The State of New Hampshire  
**DEPARTMENT OF ENVIRONMENTAL SERVICES**

Subject: Portsmouth – Former Country Motor Sales, 375 Banfield Road  
DES Site #199408047, Project #40176

*Supplemental Site Investigation Report*, prepared by Wilcox & Barton, Inc. (Wilcox & Barton), dated November 22, 2021

RE: 2 Russell St  
Meeting: TAC 09/06/22  
Packet Pages: 5 to 10 (page 20-395)

Possible Pedestrian/ Bicycle Crossing and additional sidewalk area:

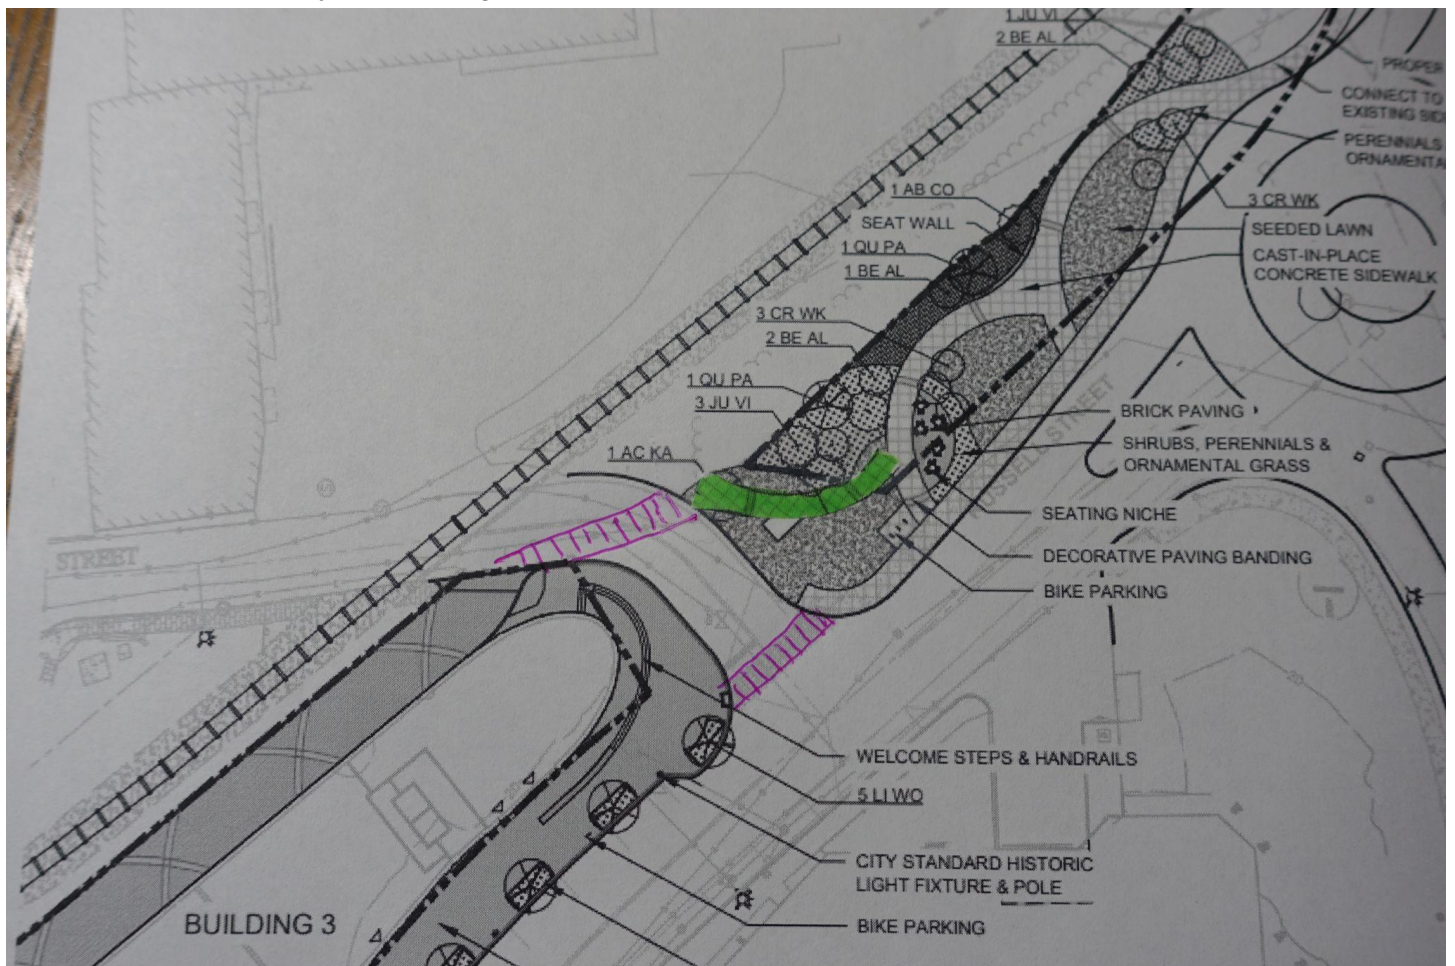
Continuing the path which runs parallel to the RR Tracks onto Lot 119-4 (park) might be helpful, otherwise bikes and pedestrians are likely to cross there anyway to get to the other side. There could be a diagonal crosswalk from parallel to the RR tracks to Lot 119-4; keeping the one parallel to Russell St. The sidewalk could be continued by turning the figure 8 sidewalk of the park in the opposite direction. Having the open part of the curve start at where the first tree 1 AC KA (Maple) is listed on the Plan L- 101 (pg 517). The other proposed connections could remain just configured a little differently (*see picture at end*).

**It may better serve the city to slightly decrease the size of the proposed sidewalks and increase the size and number of lanes on both sides of Deer St** as they approach Maplewood Ave to create less backup and better flow through the intersection for today and for the future.
